SERVICE BULLETIN

ENGINE - NO.4 BEARING COMPARTMENT - REWORK NO.4 BEARING FRONT AND REAR SEAL SEATS TO
INCORPORATE REVISED SURFACE FINISH AND HARDFACE THICKNESS - CATEGORY CODE 5 -
MOD.ENG-72-0036

V2500-ENG-72-0036

Location of No.4 bearing front and rear seal seats
Fig.1

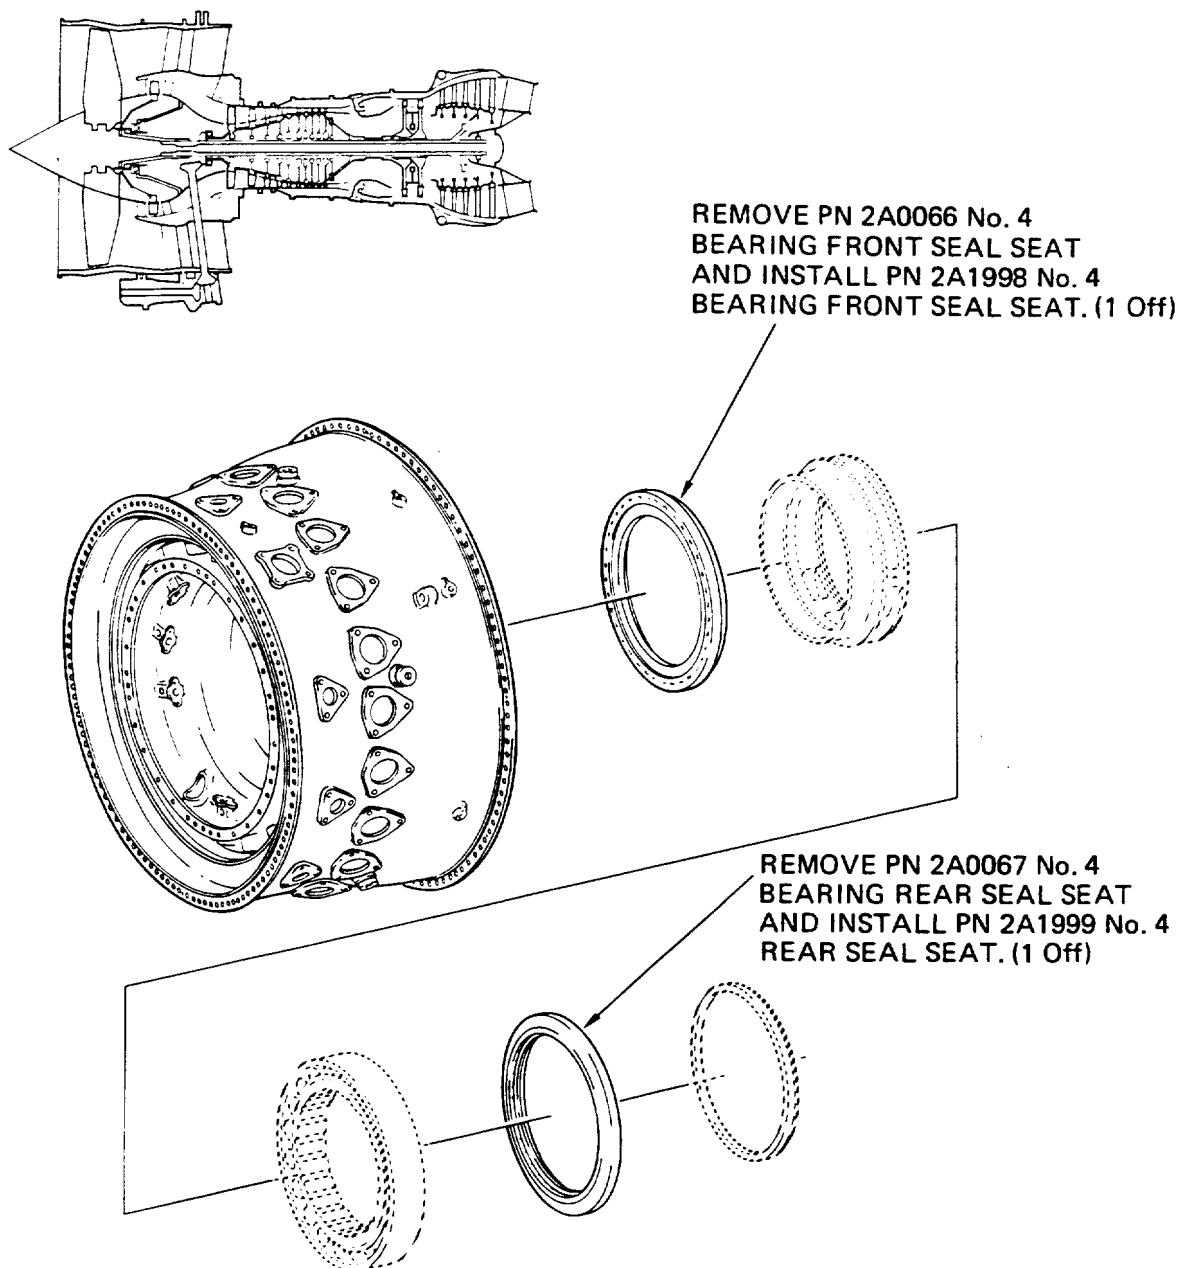
- (1) Remove the 2A0066 and 2A0067 No.4 Bearing Front and Rear Seal Seats by the instructions given in Reference (2), Chapter/Section, 72-00-43 Removal. Refer to Figure 1.

Fig.2 (Sheet 1 of 2)

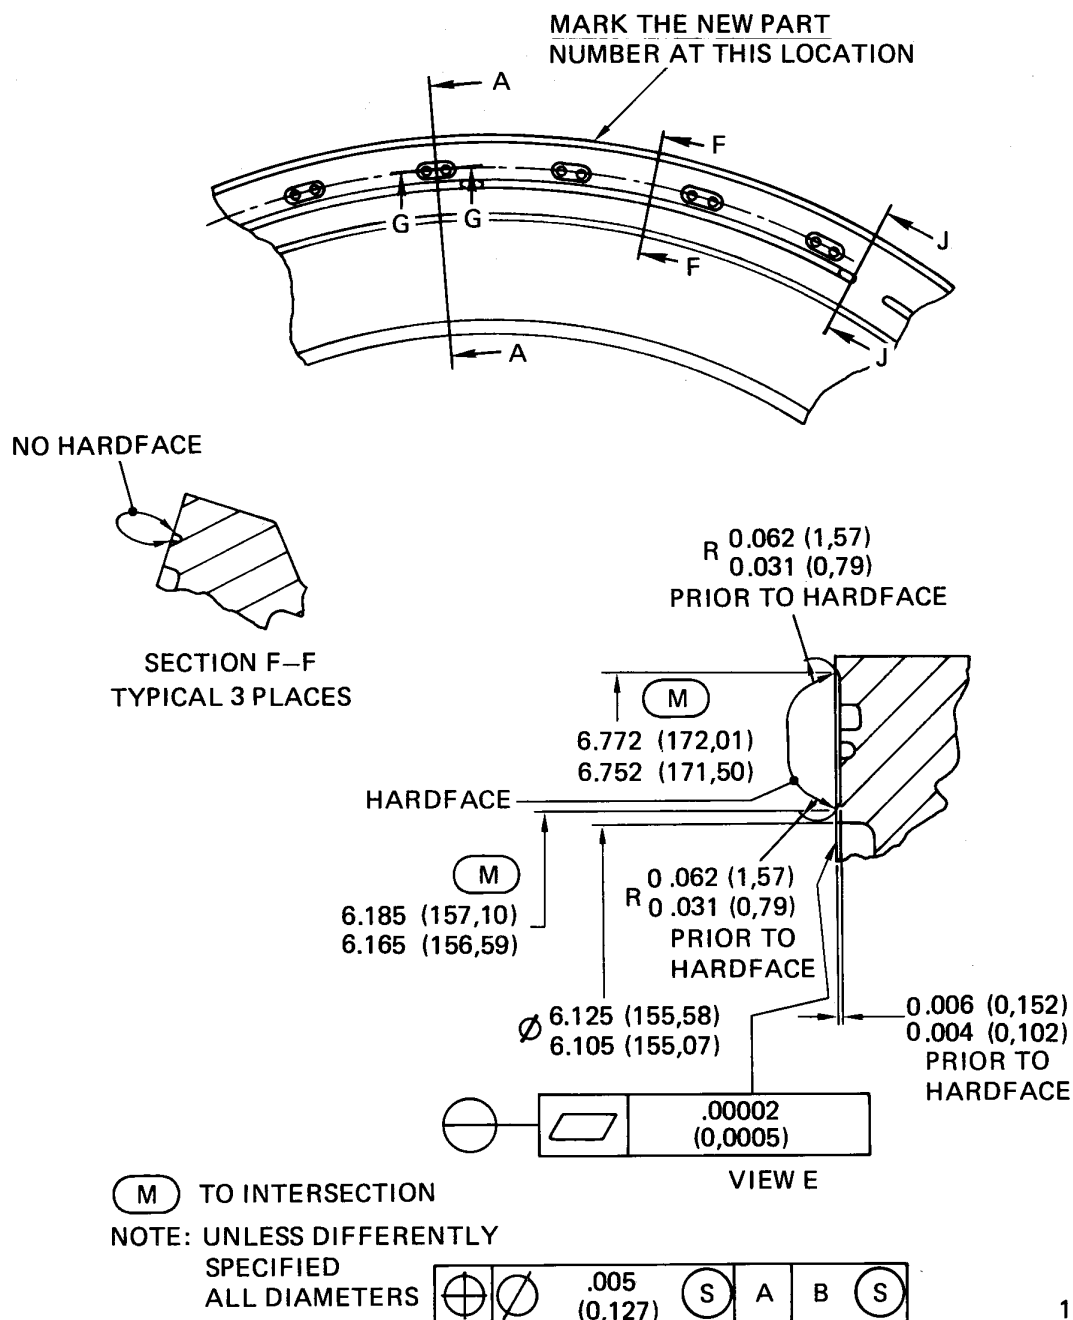
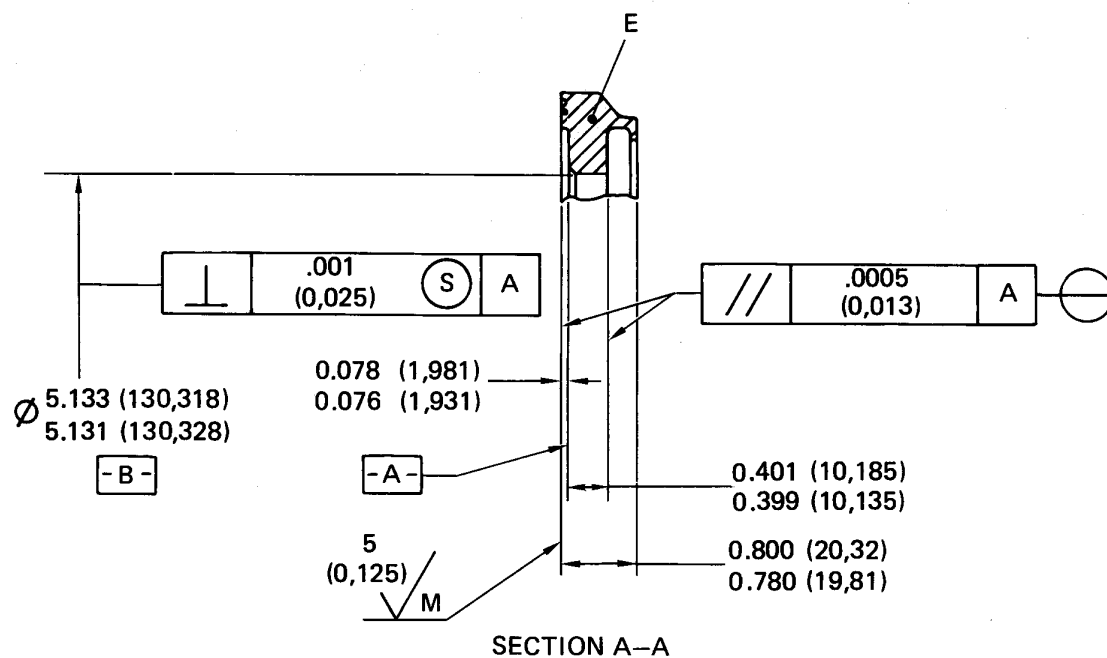
- (1) Do a modification of 2A0066 No.4 Bearing Front Seal Seat (See Reference (1), 72-43-11, Fig/Item No.01-010) and identify as follows:

| (a) Set-up and machine the No.4 Bearing Front Seal Seat | Refer to Figure 2, Sheets 1 and 2 requirements |
| (b) Hardface the enclosed area (View E) with chromium carbide coating, Make sure that no overspray goes into the areas marked "no hardface" | Refer to Figure 2, Sheets 1 and 2 for coating location which is to be applied by Reference (3), Control No./TASK 70-34-02-340-501 |

| (c) Set-up and machine to the dimensions and surface finish specified | Refer to Figure 2, Sheets 1 and 2 requirements and References (3), Control No./TASK 70-35-09-350-501 |

| (d) Make a mark adjacent to the old part number to show the new part number. Use the vibration peen method | Old Part No. New Part No.

2A0066 2A1998
Refer to Reference (3), Control No./TASK 70-09-00-400-501 |

Fig.2 (Sheet 2 of 2)

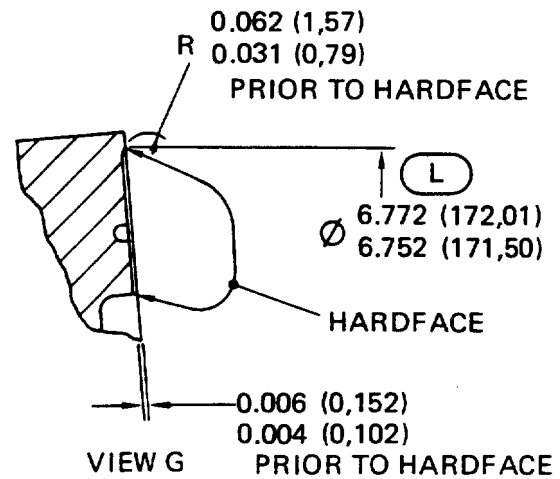
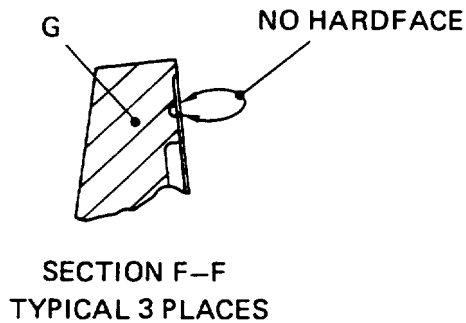
NO HARDFACE 6 PLACES

SECTION J-J

NO HARDFACE 36 PLACES

SECTION G-G

Fig.3 (Sheet 1 of 2)

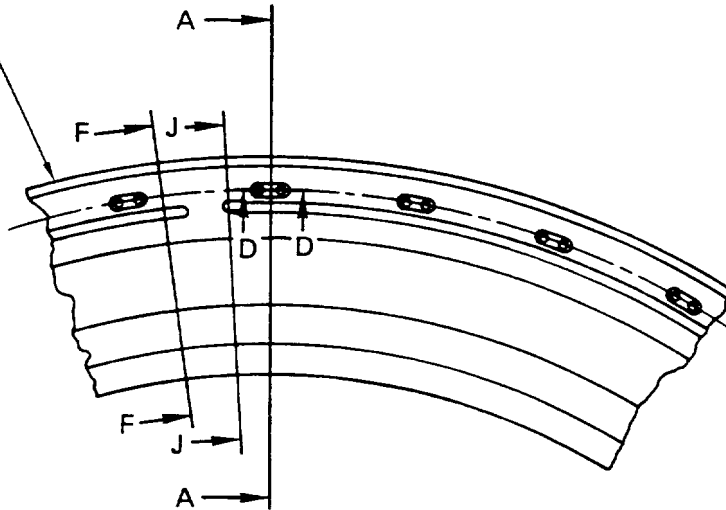
- (2) Do a modification of the 2A0067 No.4 Bearing Rear Seal Seat (See Reference (1) 72-43-14, Fig/Item No.01-020) and identify as follows:

| (a) Set-up and machine the No.4 Bearing Rear Seal Seat | Refer to Figure 3, Sheets 1 and 2 requirements |

| (b) Hardface the enclosed area (View G) with chromium carbide coating. Make sure that no overspray goes into the areas marked "no hardface" | Refer to Figure 3, Sheets 1 and 2 for coating location which is to be applied by Reference (3), Control No./TASK 70-34-02-340-501 |

| (c) Set-up and machine to the dimensions and surface finish specified | Refer to Figure 3, Sheets 1 and 2 requirements and Reference (3), Control No./TASK 70-35-09-350-501 |

- | | | | | | |
|--|---|--------------|--------------|--------|--------|
| (d) Make a mark adjacent to the old part number to show the new part number. Use the vibration peen method | <table border="0"> <tr> <td>Old Part No.</td> <td>New Part No.</td> </tr> <tr> <td>2A0067</td> <td>2A1999</td> </tr> </table> | Old Part No. | New Part No. | 2A0067 | 2A1999 |
| Old Part No. | New Part No. | | | | |
| 2A0067 | 2A1999 | | | | |

MARK THE NEW PART NUMBER
AT THIS LOCATION
